SPM 70-23-23 REMOVAL OF COATINGS BY HIGH PRESSURE WATER STRIPPING

sk70-23-23-330-081      [Technical Change: Changed procedure to do a removal of coatings by high pressure water stripping.](#)

Figure 1 Visualization of High Pressure Water Jet Parameters

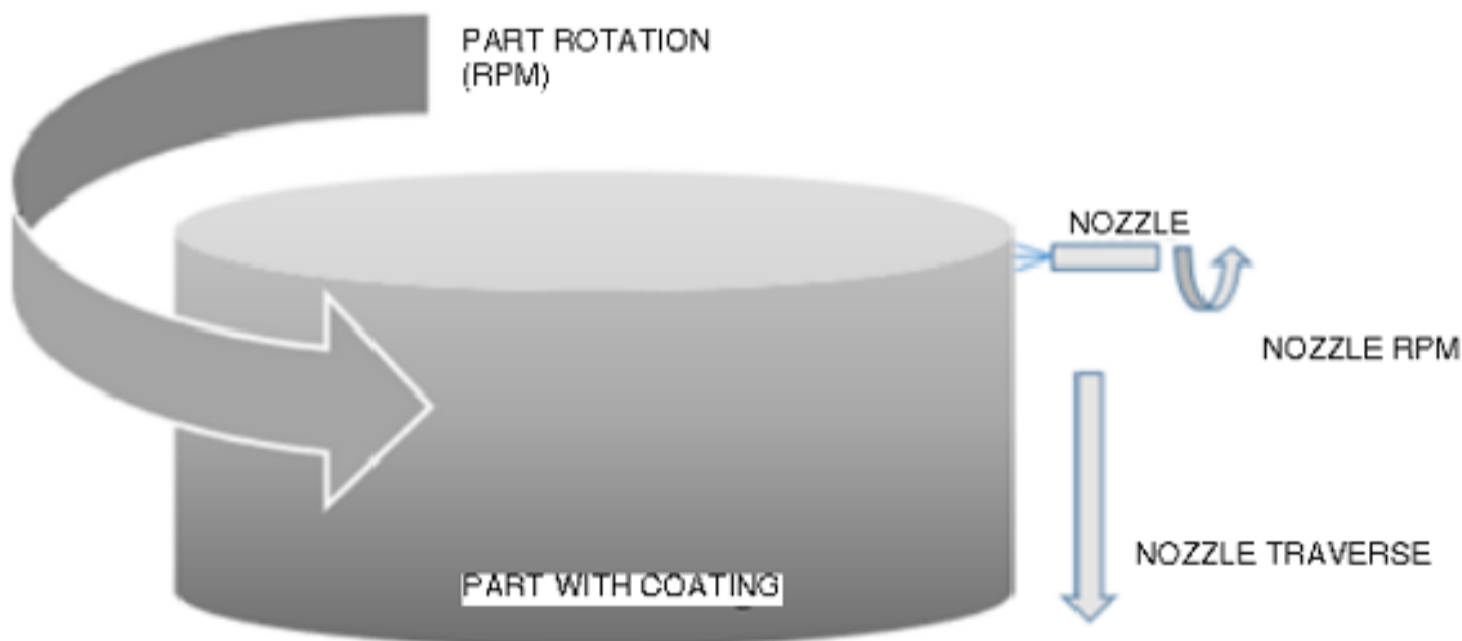
- (4) Relation between system parameters. Refer to [Figure 1](#) and as follows:
  - (a)  $IPM$  (inch per min) or  $SFM = n * D * .$
  - (b) Turntable  $RPM = IPM$  or  $SFM = * D.$

Figure 2 Unwanted Visual Appearance after High Pressure Water Jet Stripping Process

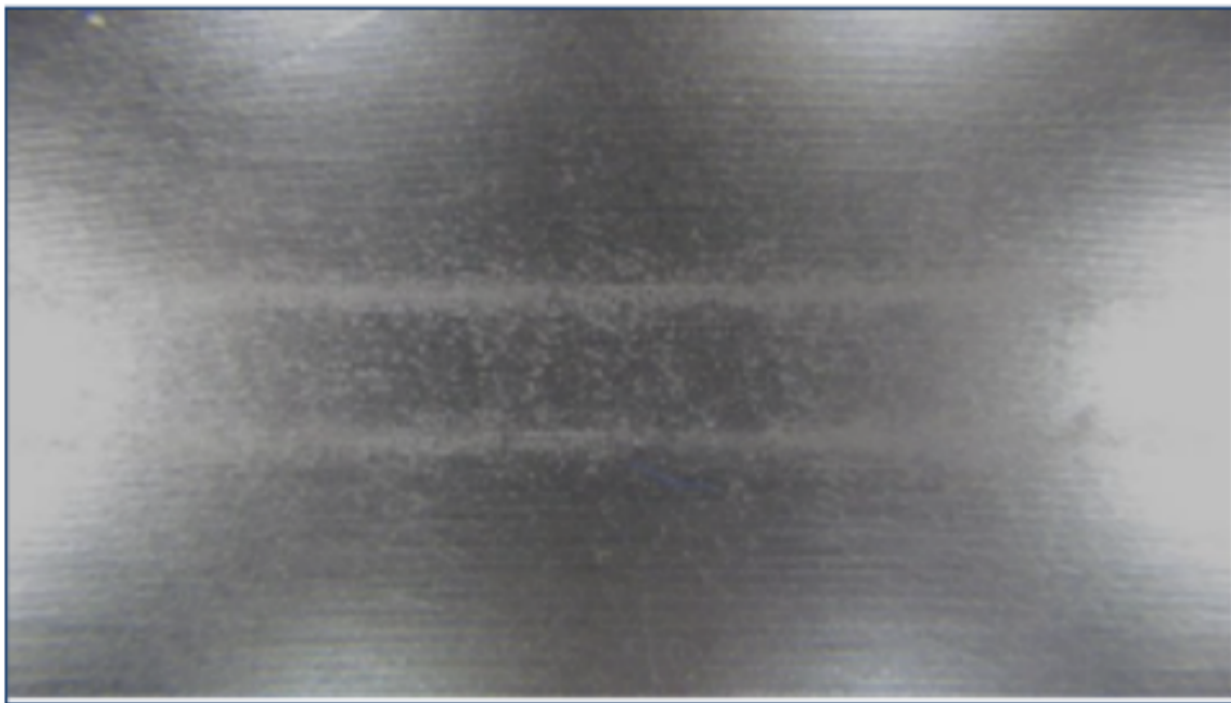
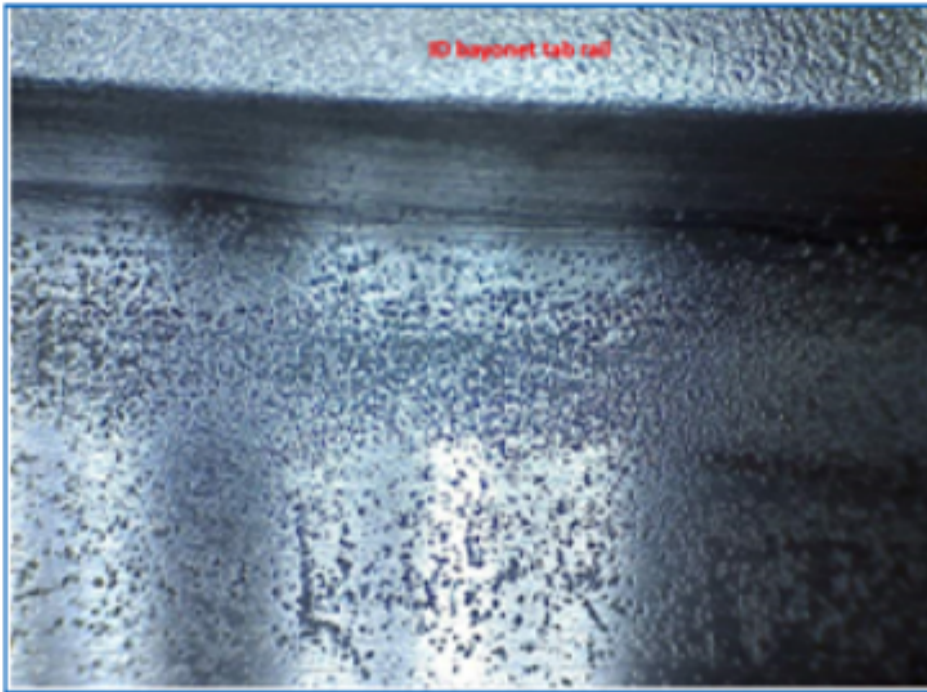
- (d) Visually inspect the processed area, visual evidence of pitting after high pressure water jet stripping is not permitted. Refer to [Figure 2](#).

Figure 3 Coupon Preparation Steps to Metallographically Measure the Material Removal

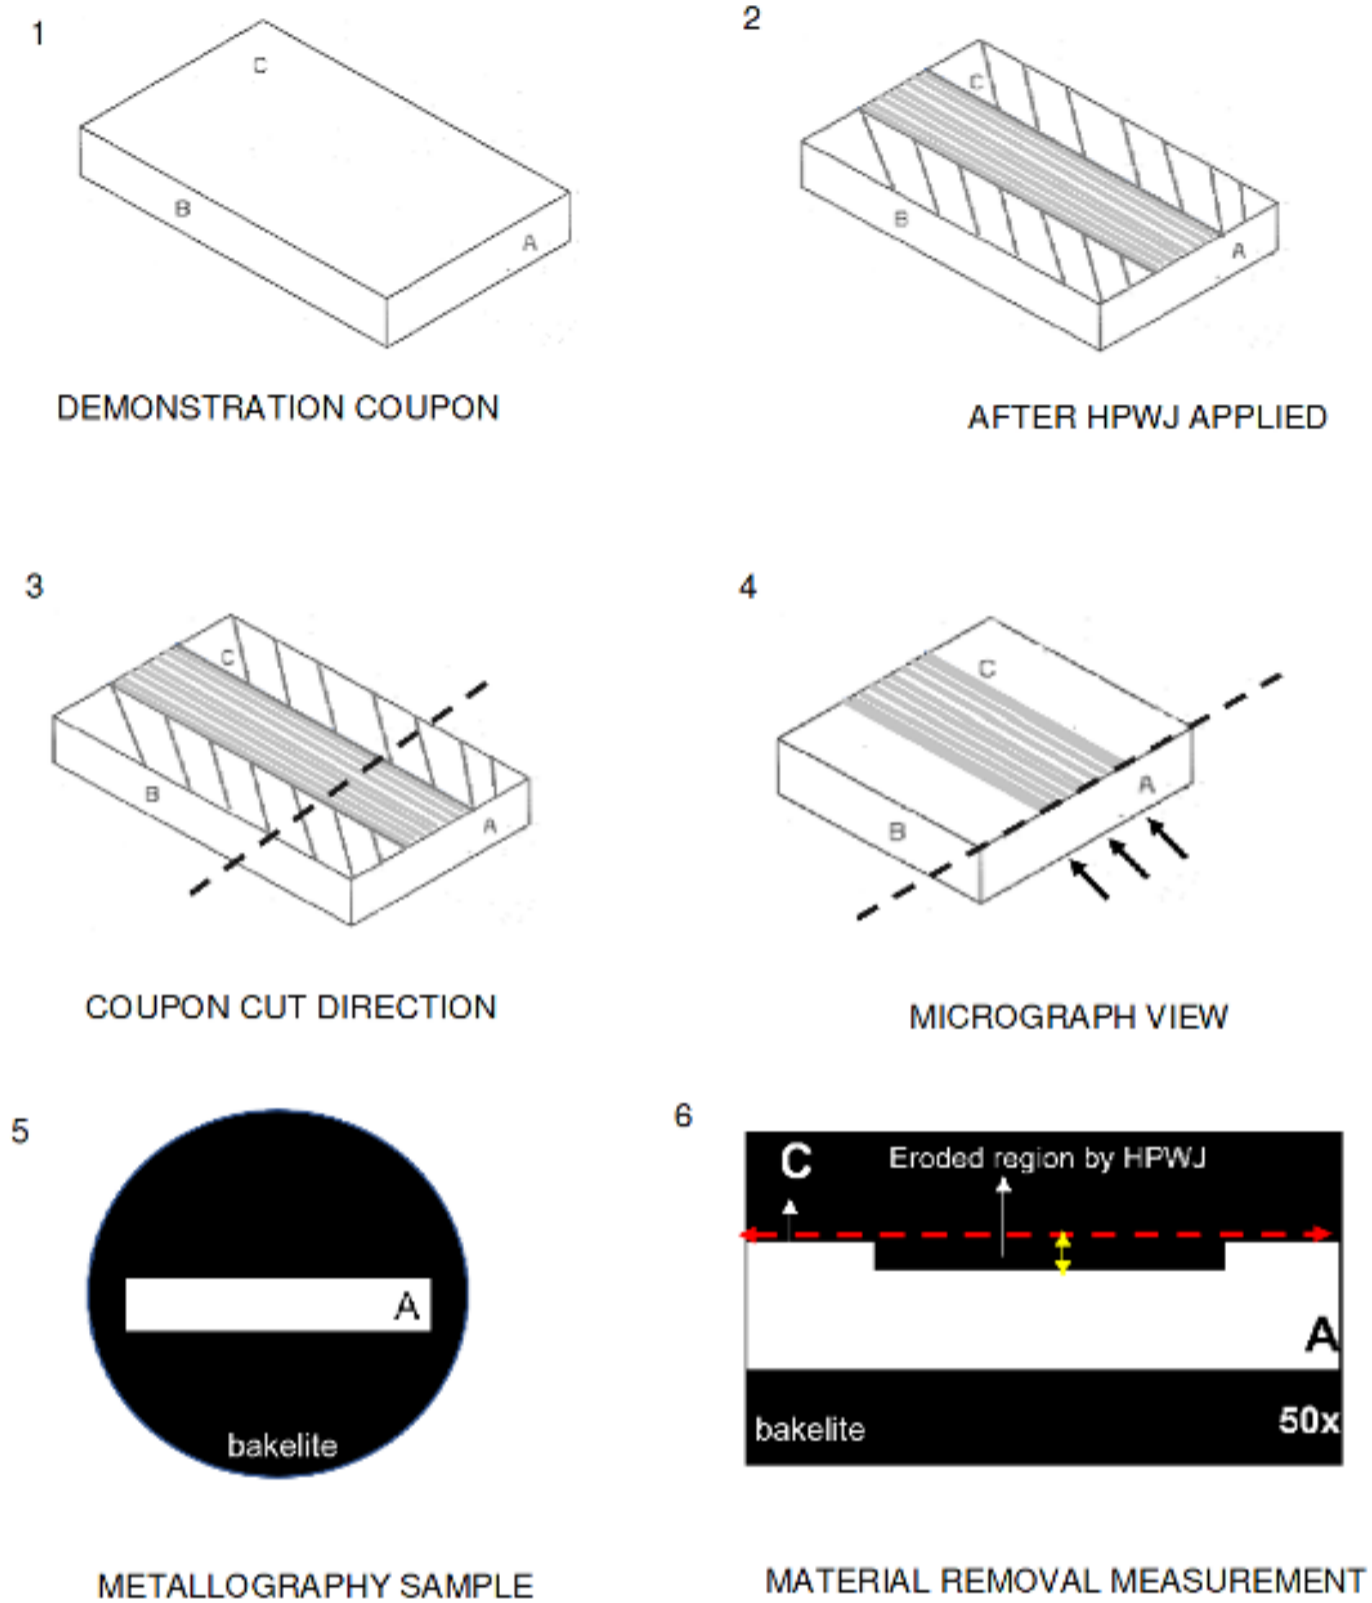
- (e) Metallographically examine coupons with photo micrographs or by 3D measurement system that is able to scan the coupon area to find maximum material removal. Refer to [Figure 3](#) to metallographic coupon preparation steps.
